# Module TX eye measurement method proposal

In support of comment #148

IEEE 802.3bs 400 Gb/s Task Force

Macau, March 2016

# Far-end eye parameters

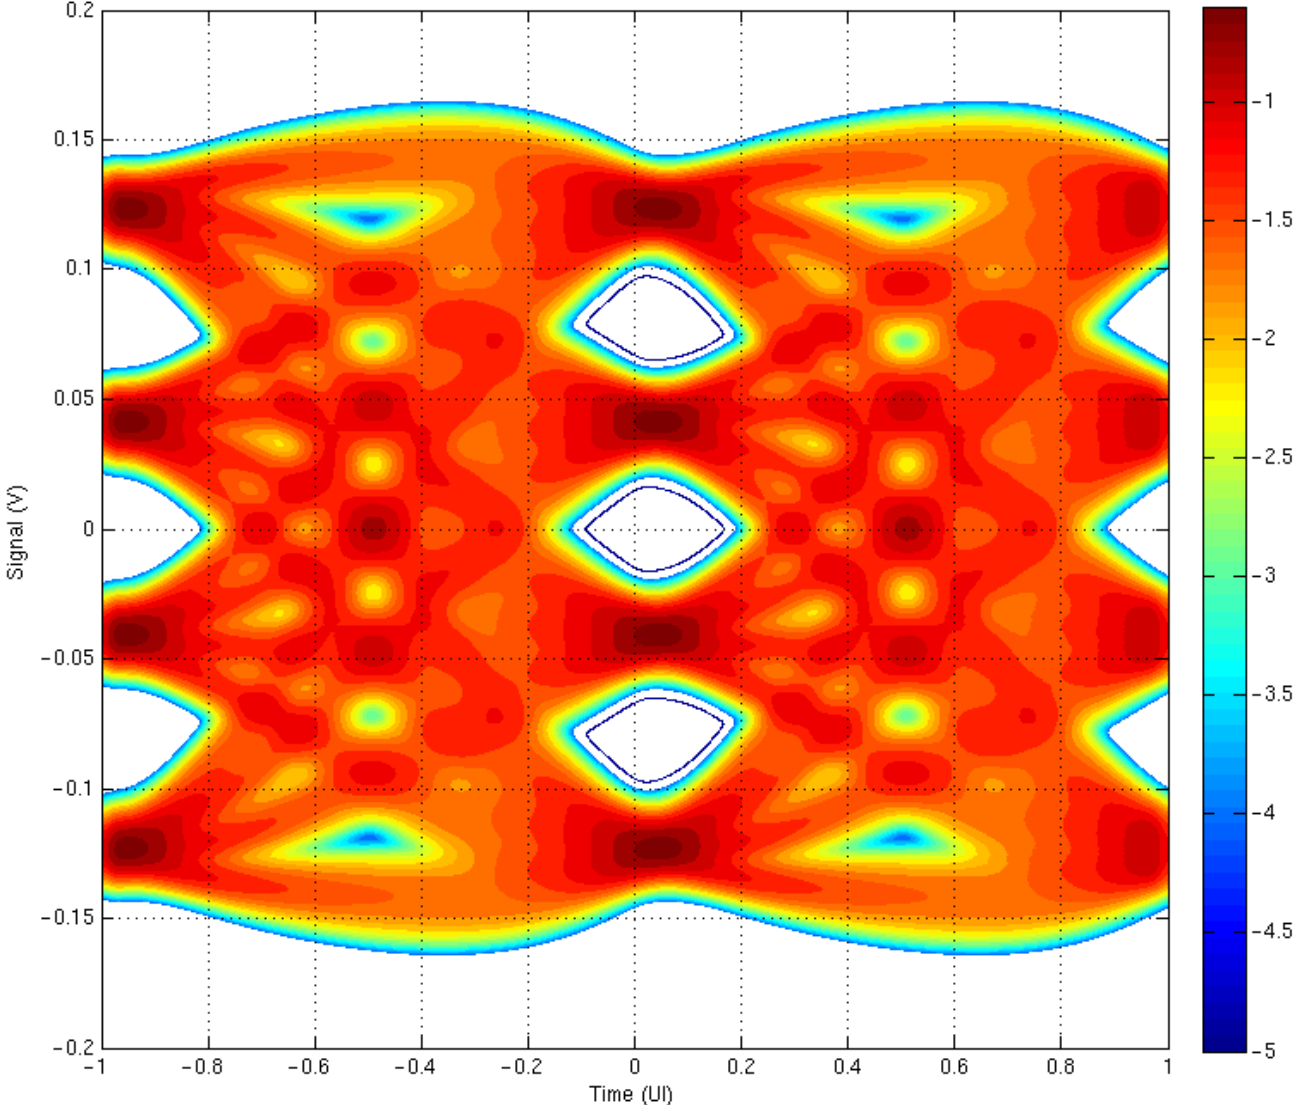
- Short channel model (~2.5dB loss at Nyquist/2) from CDAUI-8 is used to represent the MCB trace
- Driver+Pkg representative of a typical module, TX coef. = [-0.1 0.9]
- CDAUI-8 C2C jitter parameters
- Post processing:
  - ~7.5dB channel loss to represent the far-end scenario
  - 4<sup>th</sup> order Bessel-Thomson low-pass with 33GHz 3dB b/w
  - Search over all CTLE settings to obtain the best eye opening

Parameter	Value
ESMW	220mUI
Eye Width	250mUI
Eye Height	30mV

# Near-end eye parameters

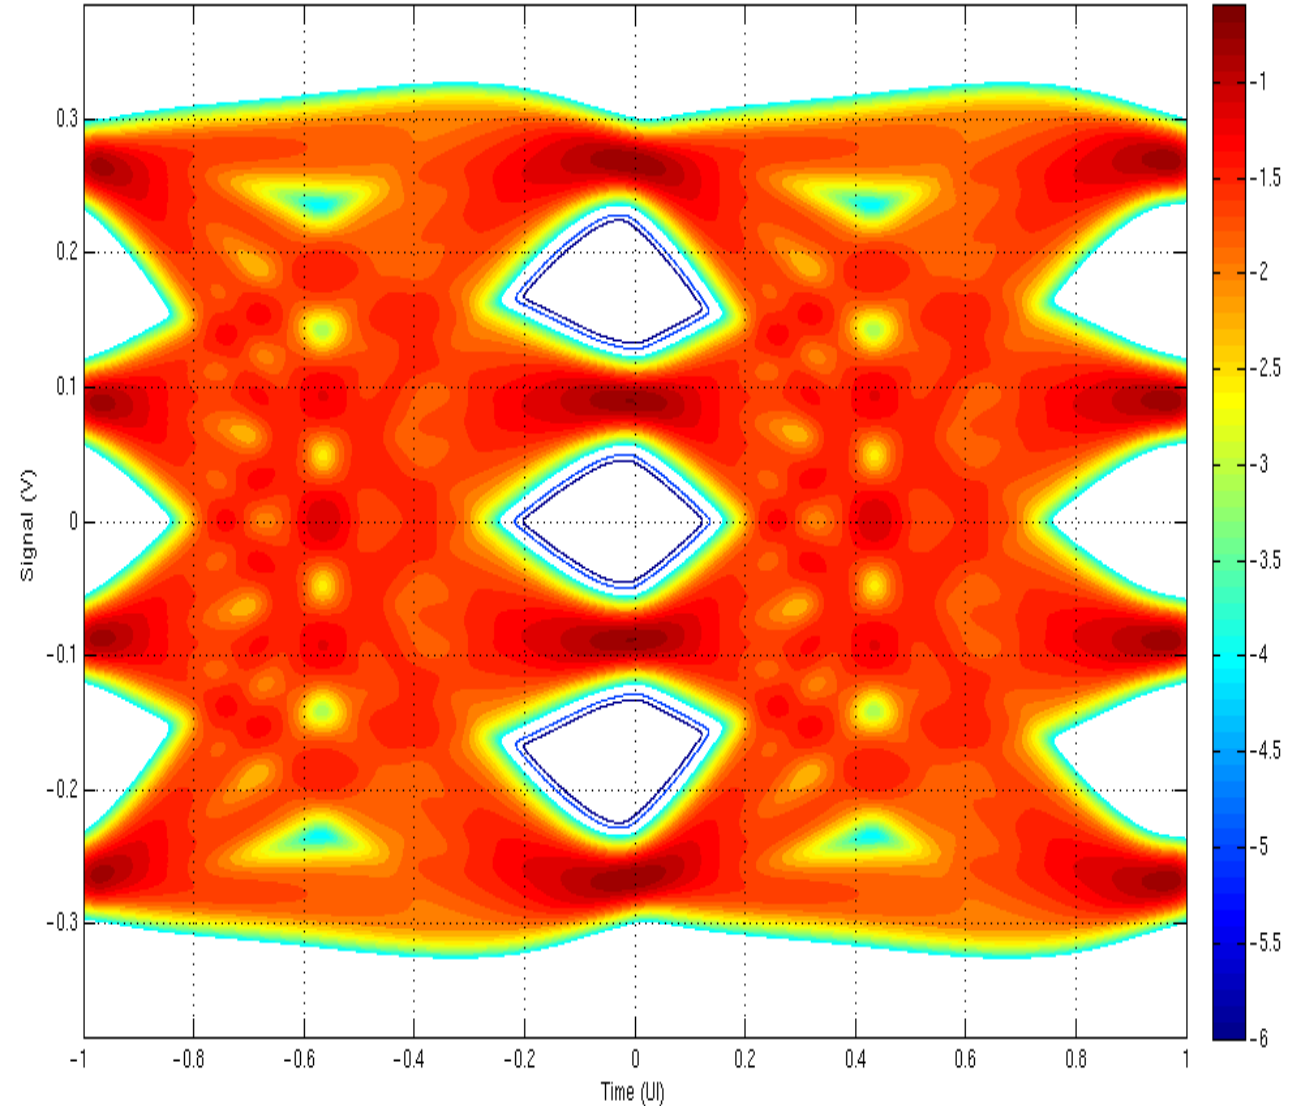
Short channel model (~2.5dB) from CDAUI-8 and CTLE sweep

Parameter	Value
ESMW	265mUI
Eye Width	325mUI
Eye Height	90mV
